**MEHL Integrated Waste
Management Facility**

EPA Waste Licence Application
W0129-03. Response to EPA Article
16: Groundwater

Issue 1 | 16 October 2013

Figure 3

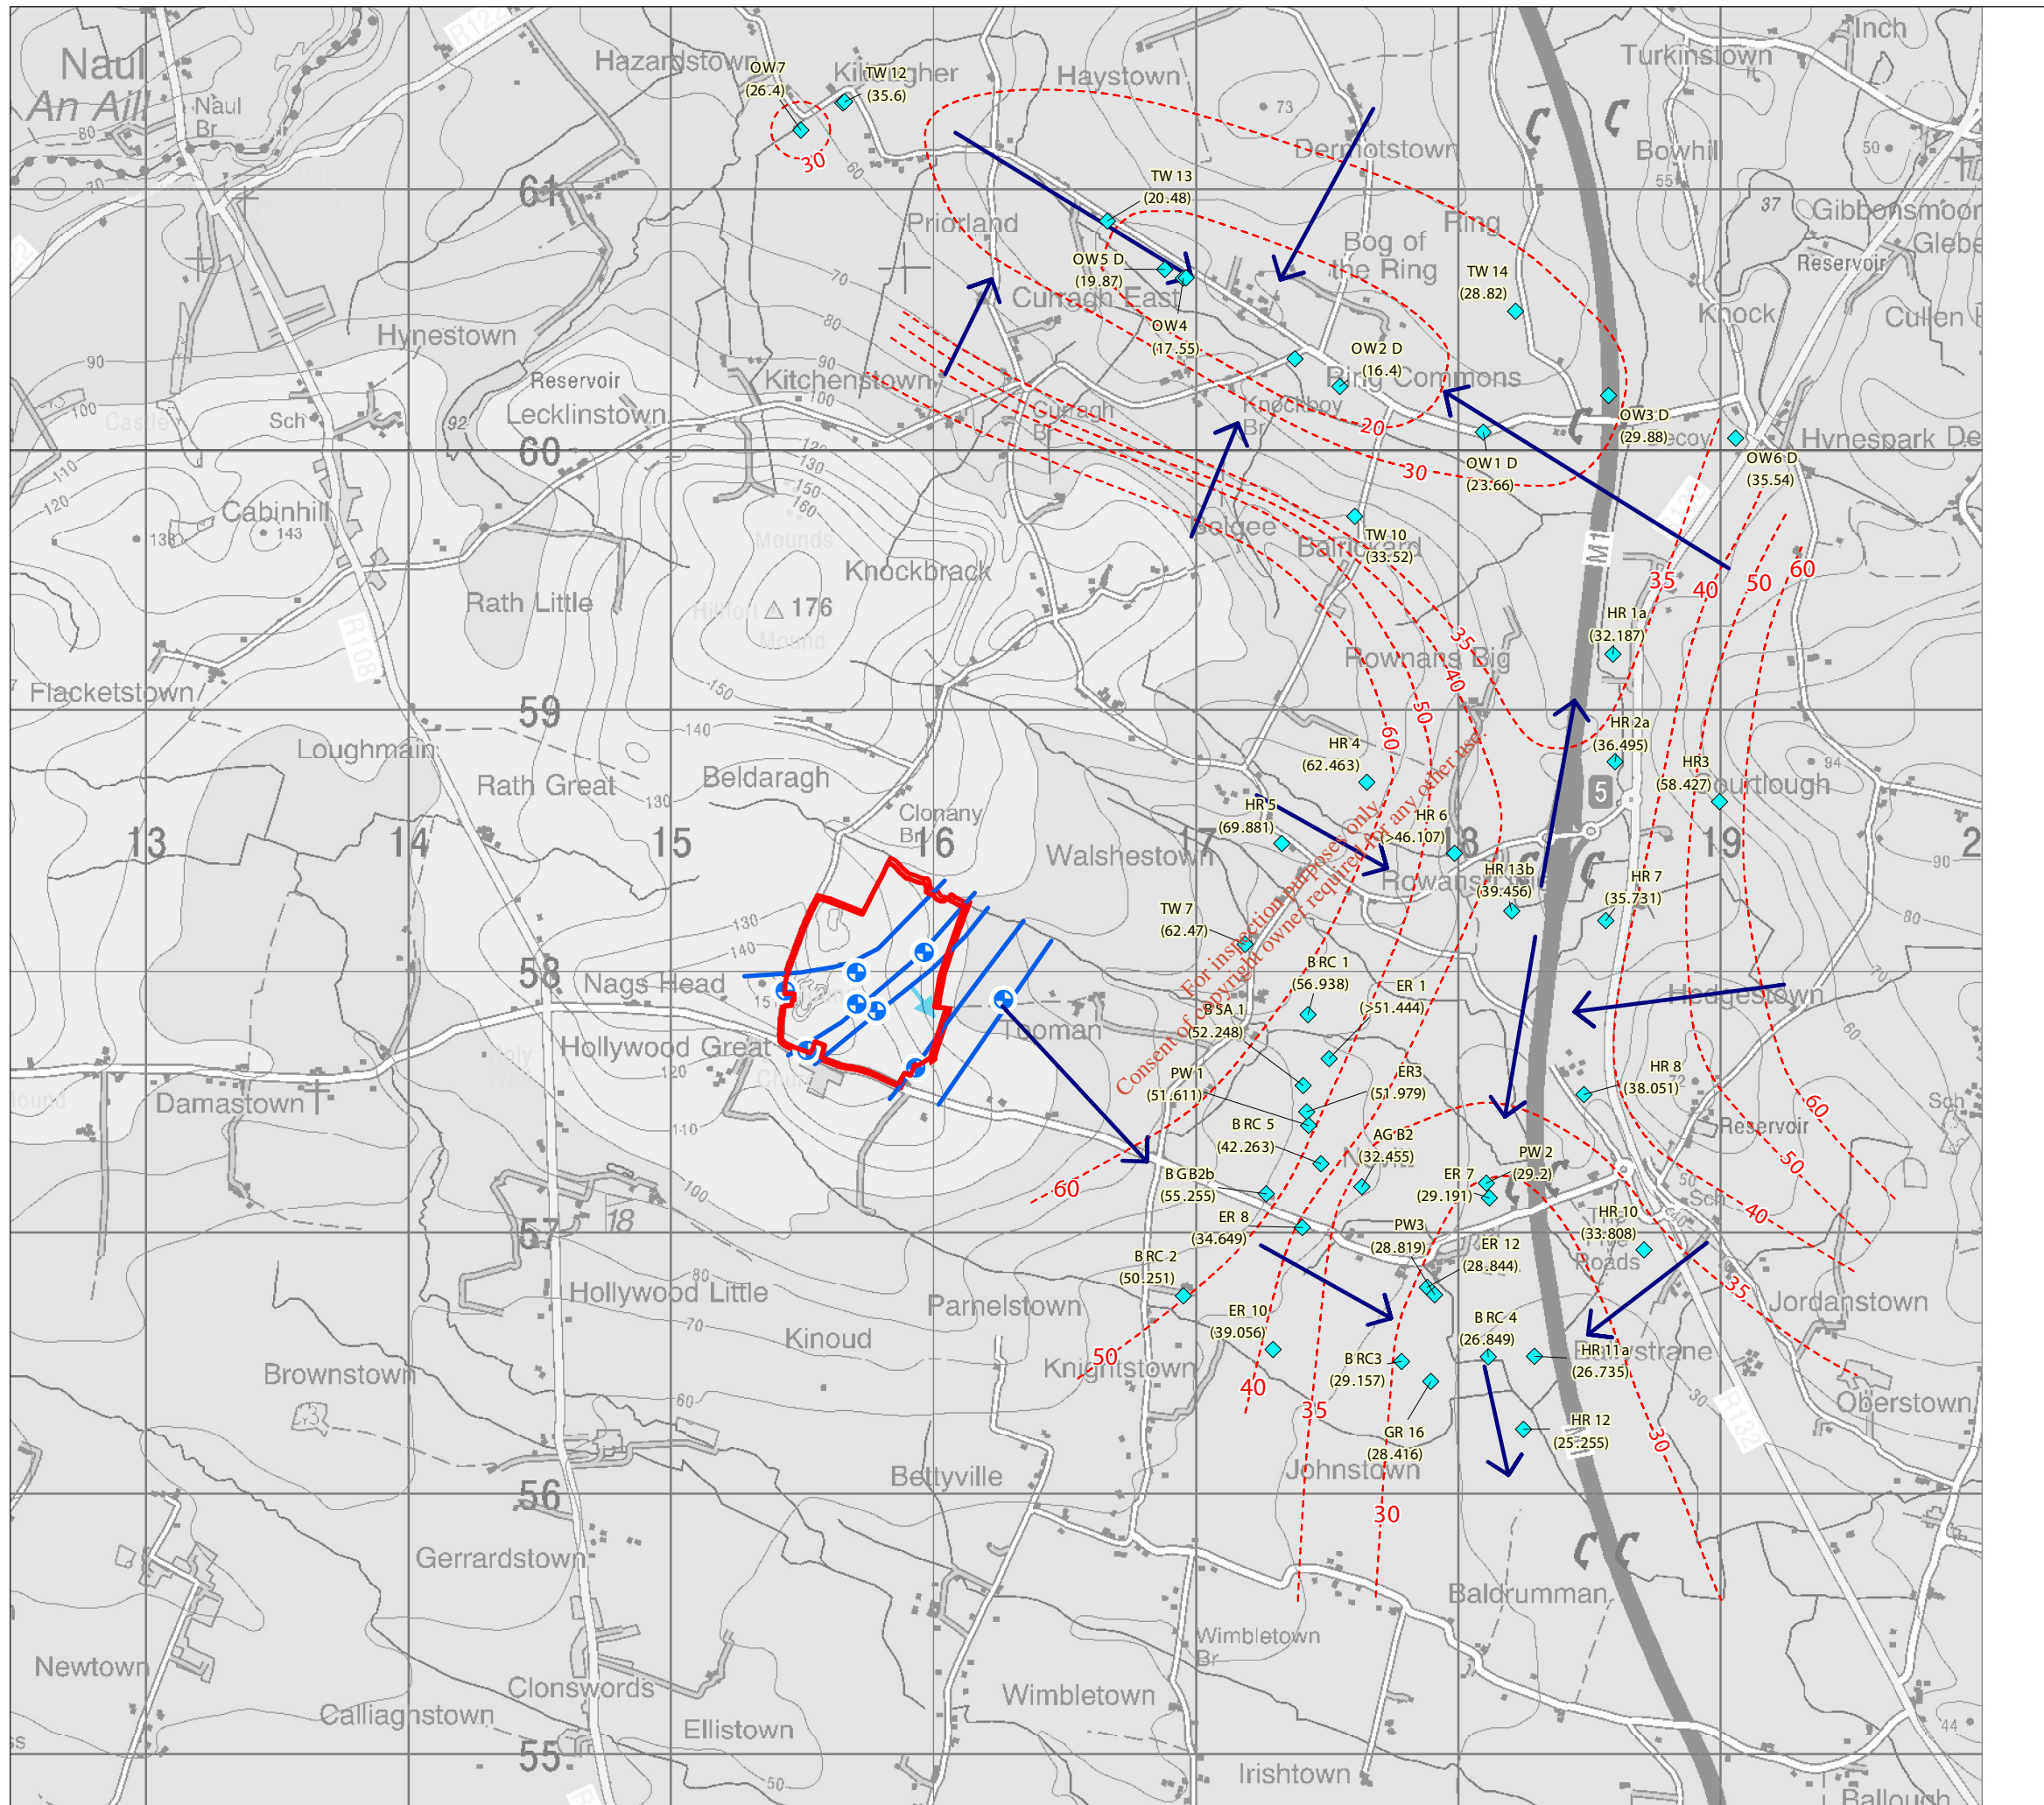
b) A plan showing regional groundwater flow, based on measured water levels and including a more accurate depiction of the groundwater divide between the site and the Bog of the Ring.

6.3. Provide separate figures showing the shallow (Namurian) and deeper (Loughshinny) groundwater flow regimes. Also present groundwater flow in a regional context on a detailed figure including site and off-site data, householder/farm wells and the Bog of the Ring water supply wells and trial wells (Figure 12 of the Hydrogeological Quantitative Risk Assessment only shows the local site groundwater flow regime).

A figure showing the regional groundwater flow, based on measured groundwater levels is presented in **Figure 3**. The regional groundwater level information for this figure was compiled using data gathered for the Fingal landfill project which was collected on the 24th of June 2005.

Groundwater level data was not available for the MEHL site for the 24th of June 2005 which is the date of the data used to create the regional information for **Figure 3**. For this reason only the general groundwater flow contours and flow direction (without quoting specific groundwater levels) from the aquifer beneath the MEHL site, as indicated in **Figure 4**, have been presented on **Figure 3**.

The local groundwater flow pattern observed at the MEHL site shown in **Figure 4** clearly coincides with the regional groundwater level pattern shown in **Figure 3**.

The groundwater divide between the MEHL site and the Bog of the Ring can also clearly be seen in the groundwater flow contours on **Figure 3**.

**Figure 4.
Groundwater levels and contours:
Loughshinny Formation
8th July 2013**

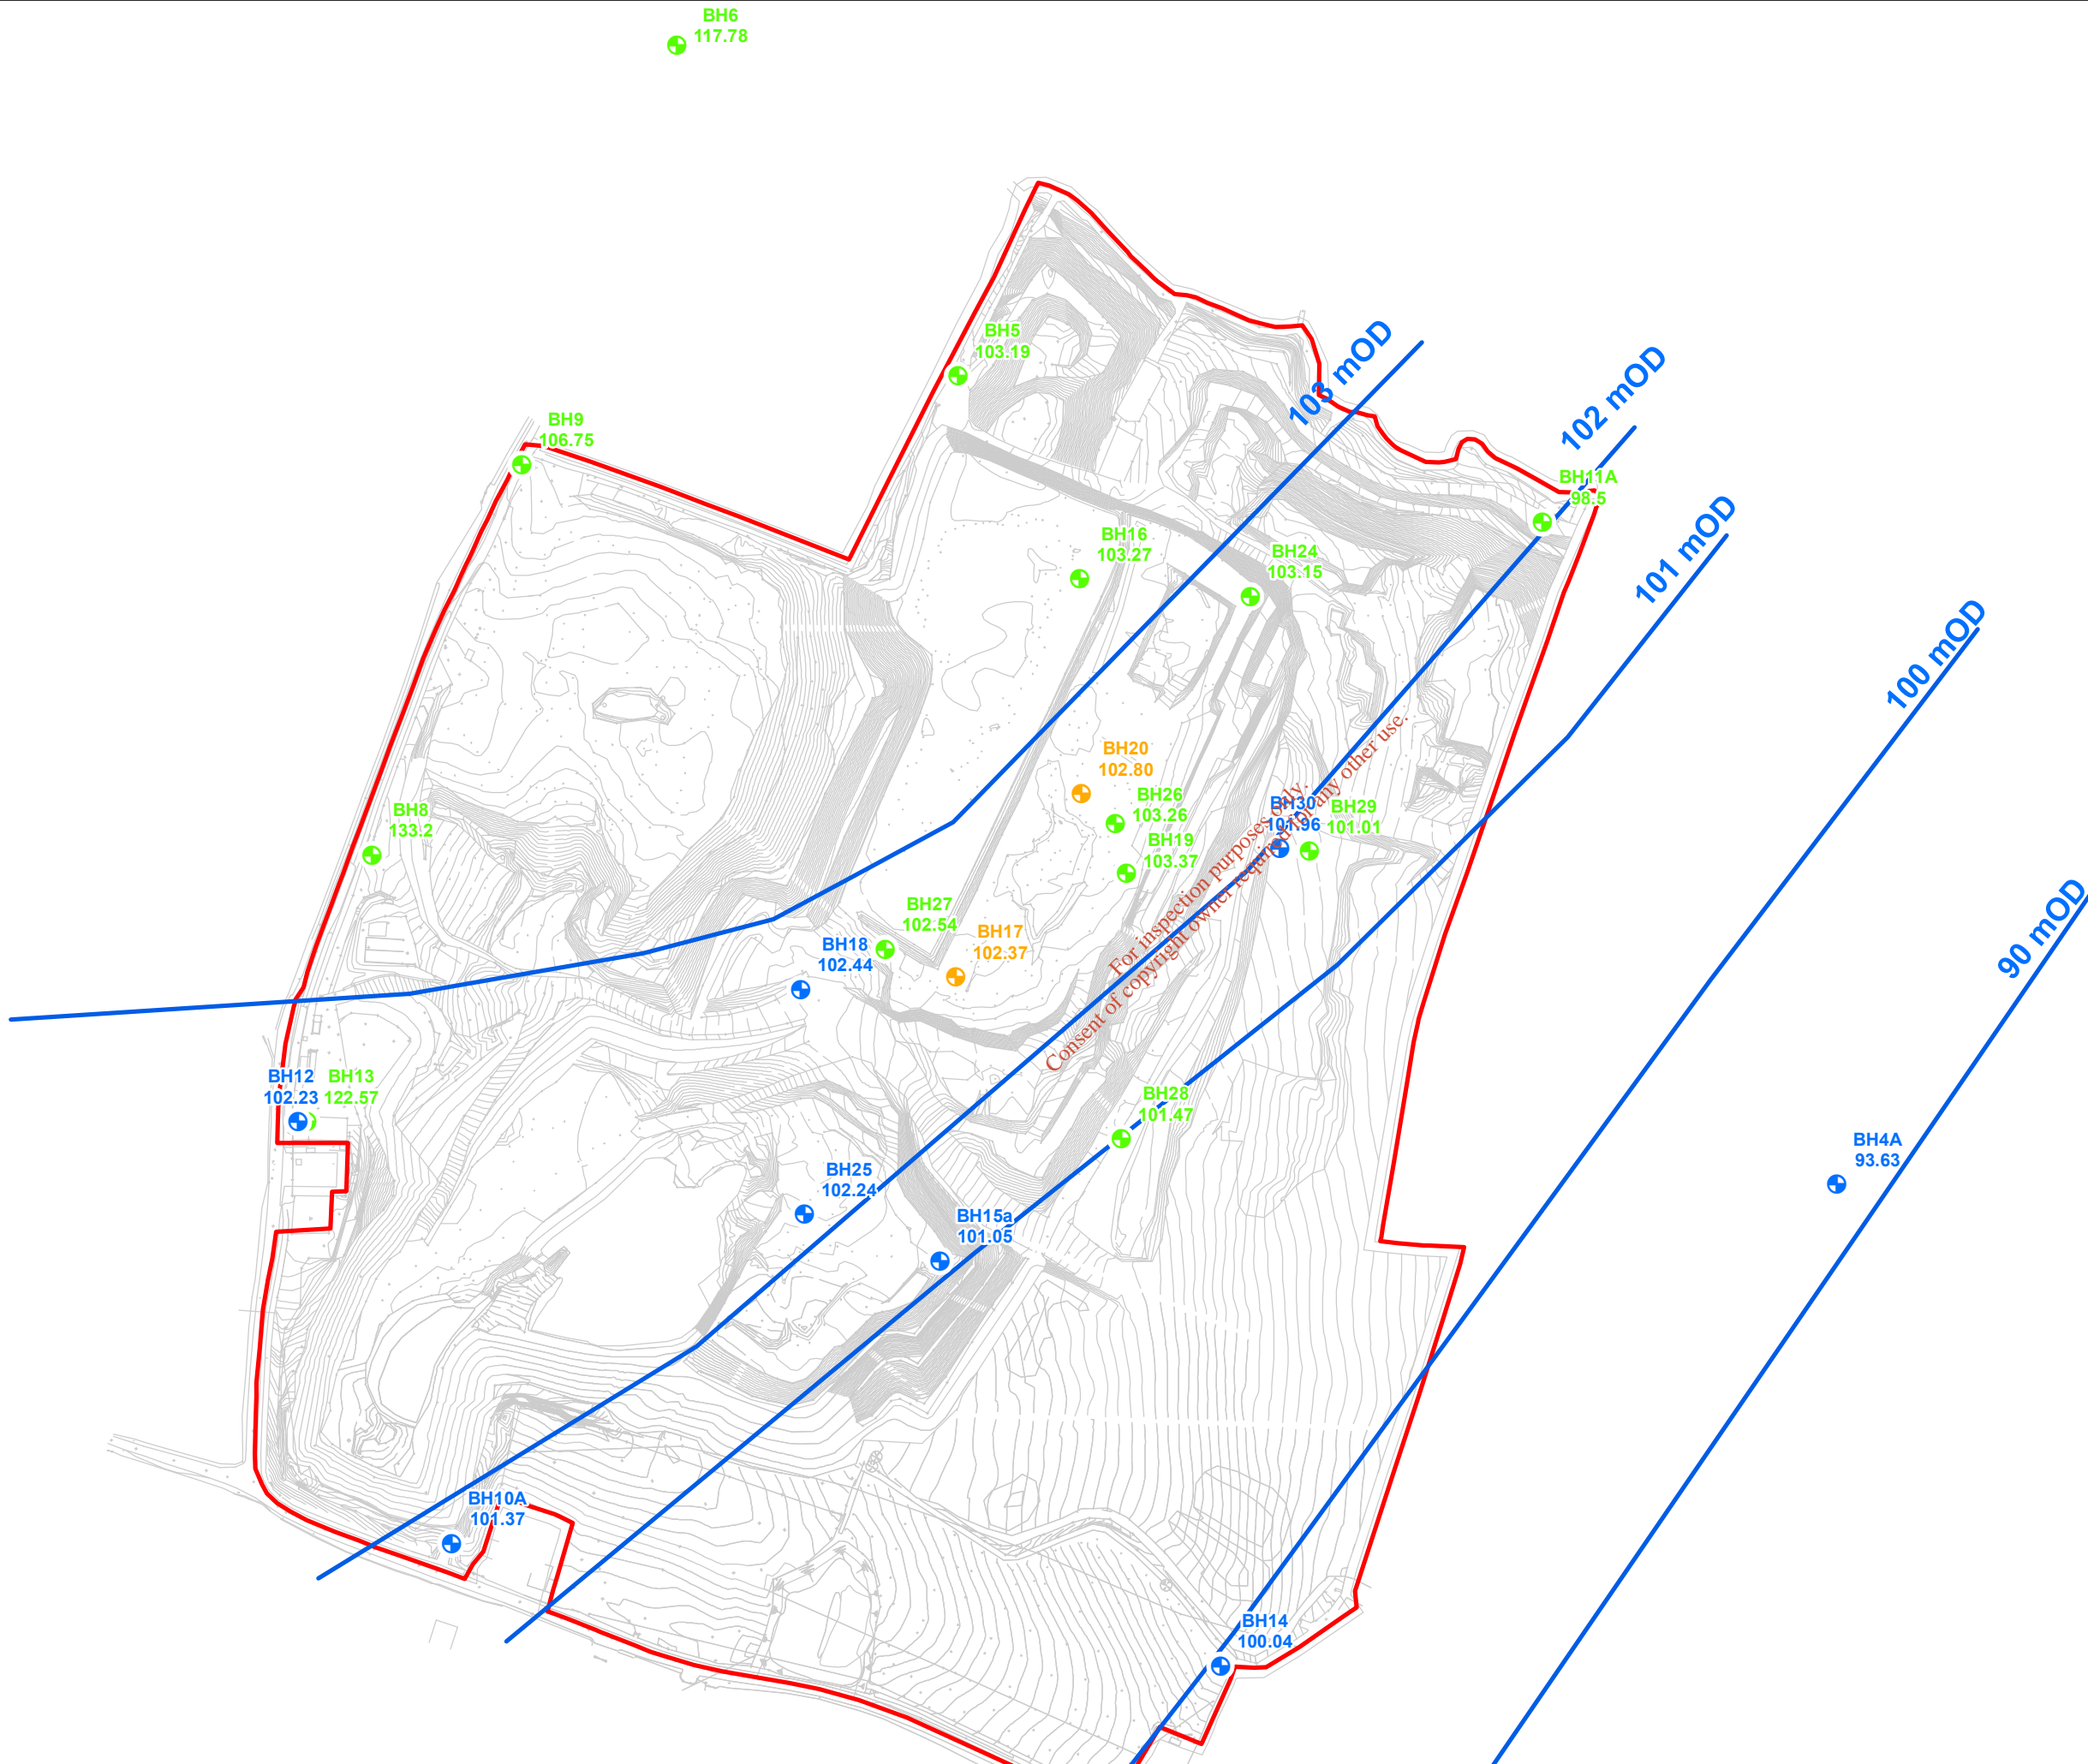
c) Two separate plans, one showing local groundwater piezometry in the Namurian Formation and one showing it in the Loughshinny Formation;

Figure 4 presents the recorded groundwater levels in the Loughshinny Formation from all the active wells on site.

- **Figure 4:** Groundwater levels measured in the Loughshinny Formation
- **Figure 5:** Groundwater levels measured in the Namurian strata.
- **Figure 6:** Groundwater contours for both the Visean and Namurian strata
